Midway City Council
7 July 2020
Regular Meeting

Whispering Creek Estates /
Preliminary Approval

CITY COUNCIL MEETING STAFF REPORT

Subject: Whispering Creek Estates – Preliminary Review

SITE PLAN

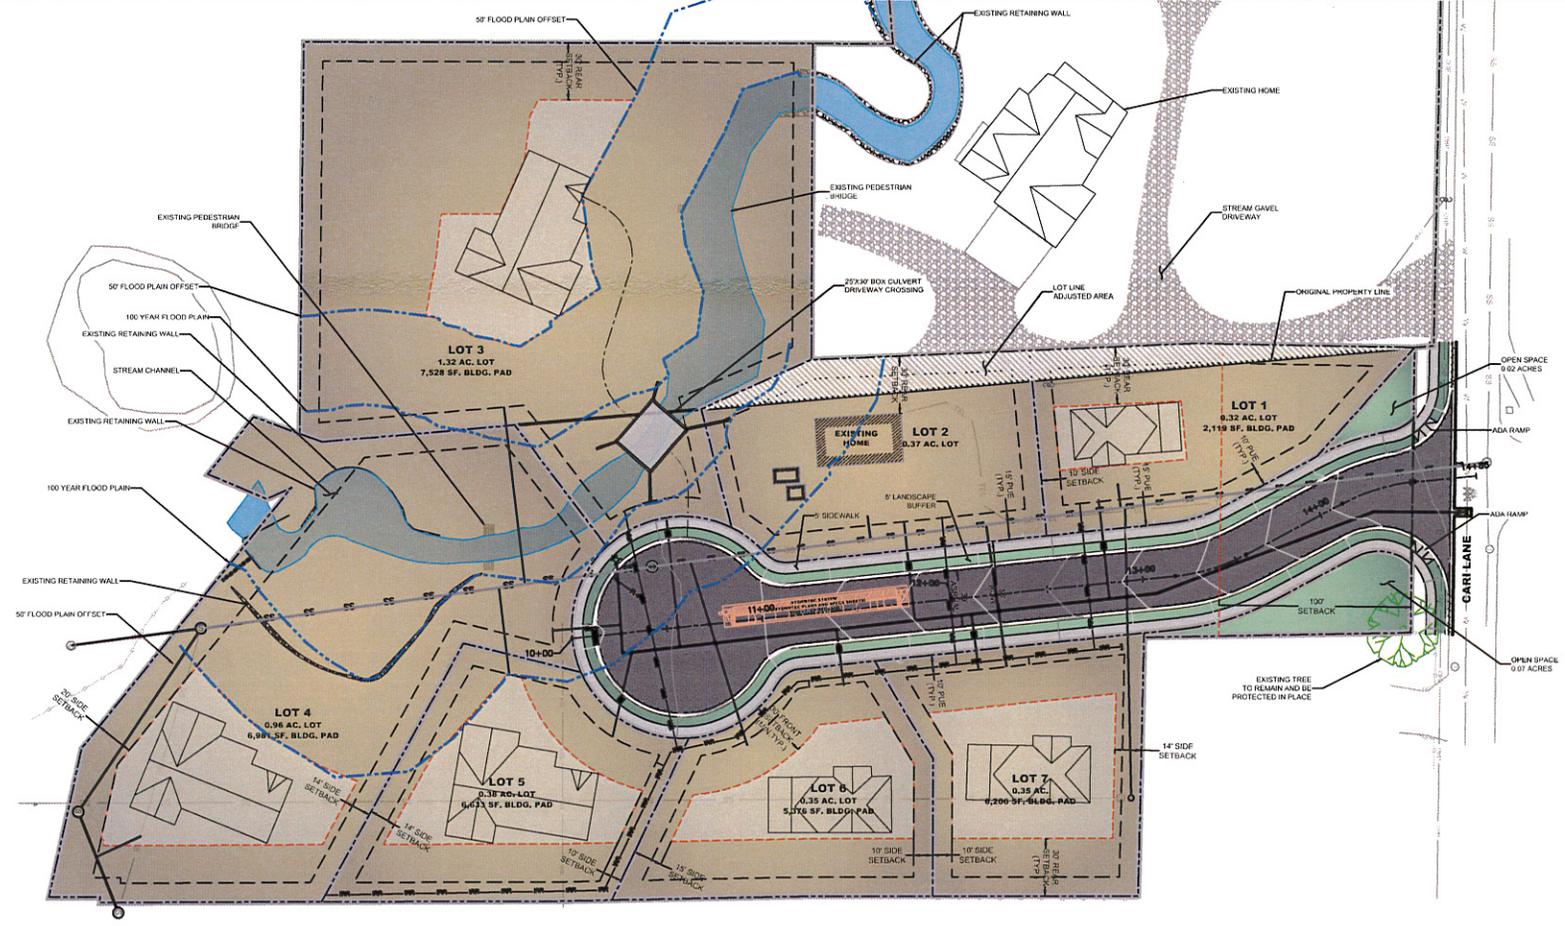
The proposal includes FEMA flood zone areas including Zone AE (1% annual flood) which requires a 50' setback. The 50' setback has been marked on the plans from Zone AE. No structures may be located in this area, but the setback area may be filled and landscaped. Landscaping is allowed in the FEMA flood area, but nothing is allowed that will modify the FEMA flood zone, this includes placing rocks or fill of any type in this area that impacts the functionality of the floodplain. There is area in the subdivision that is designated Zone X which is area of the 500-year flood (0.2%

annual chance flood) and is considered a low risk area but there is flooding potential. Flood insurance is not federally required but it is recommended in the Zone X area. A note should be placed on the plat that advises future owners of lots 4 and a small section of lots 2 and 5 (though the dwelling may be located completely outside of the zone on lots 2 and 5) of the potential flood hazard. To meet the 50' setback, the building pads for lots 4 and 5 must be adjusted.

100' Setback Requirement – The subdivision code requires a 100' setback from the edge of the right-of-way for Cari Lane for any structures. The setback line will be noted on the plat so no structures, including accessory structures, are placed in this area.

Lot 3 Access – The driveway for lot 3 will cross Snake Creek and a Stream Alteration Permit is required for the crossing. Approval for the crossing must be given by the Army Corps of Engineers before the subdivision receives final approval. The developer must build the crossing to lot 3 as part of the subdivision infrastructure.

1. A wetlands study must be approved by the Army Corps of Engineers before the item is receives preliminary approval by the City Council.
2. A stream alteration permit must be approved before final approval is granted by the City Council.
3. A note shall be placed on the plat that advises future owners of lots 2, 4 and 5 of the potential flood hazards.
4. The developer must build the driveway crossing in lot 3 as part of the subdivision infrastructure.
5. The building envelope for lot 5 must be updated so that no part of the building envelope is within 50' of the FEMA Zone AE floodplain.

SHEET TITLE
WETLAND/FLOOD MAP

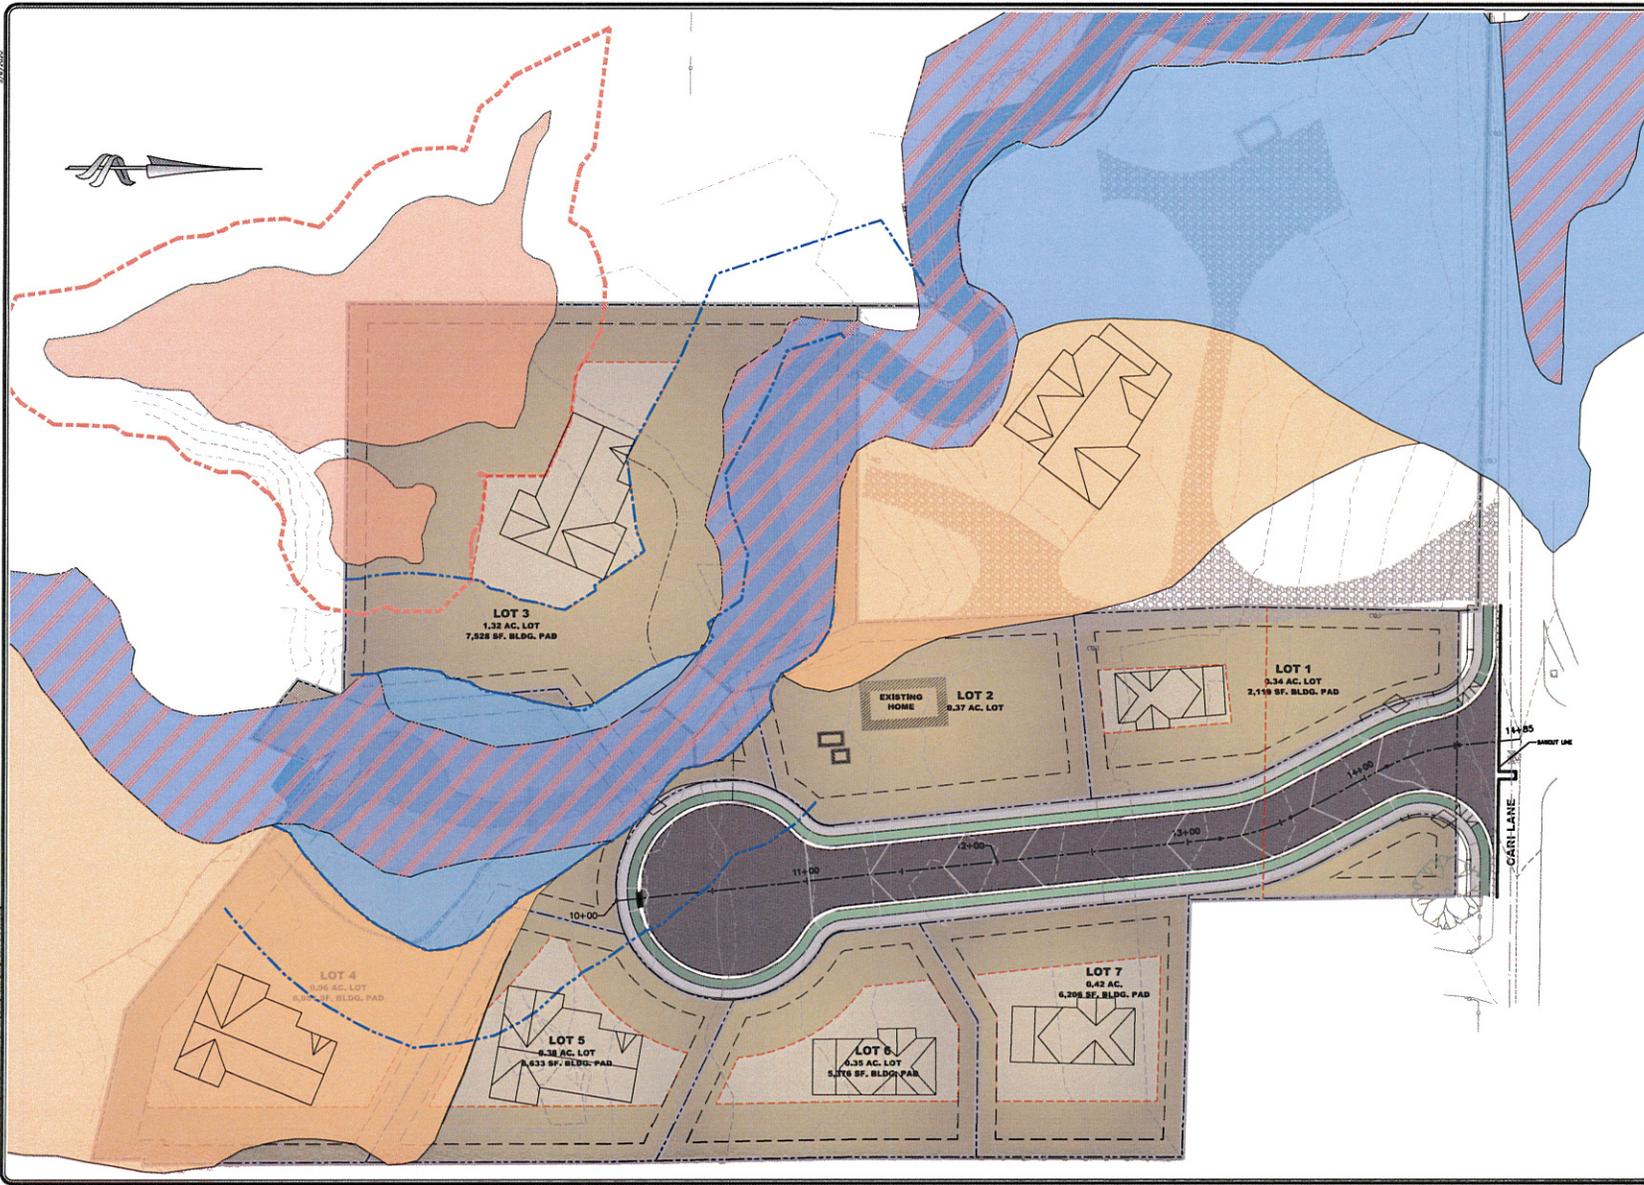
- A stream alteration permit should be obtained prior to application for final approval.
- A wetland delineation has been submitted to the Army Corp. The Corp should accept the delineation prior to approval.
- The wet land and flood plains with their required setbacks on plans should be shown on the plat map.

- The 25 foot setbacks shall be maintain around all delineated wet lands as approved by the Corp.
- The 50' setbacks shall be maintained around all FEMA flood Zones.
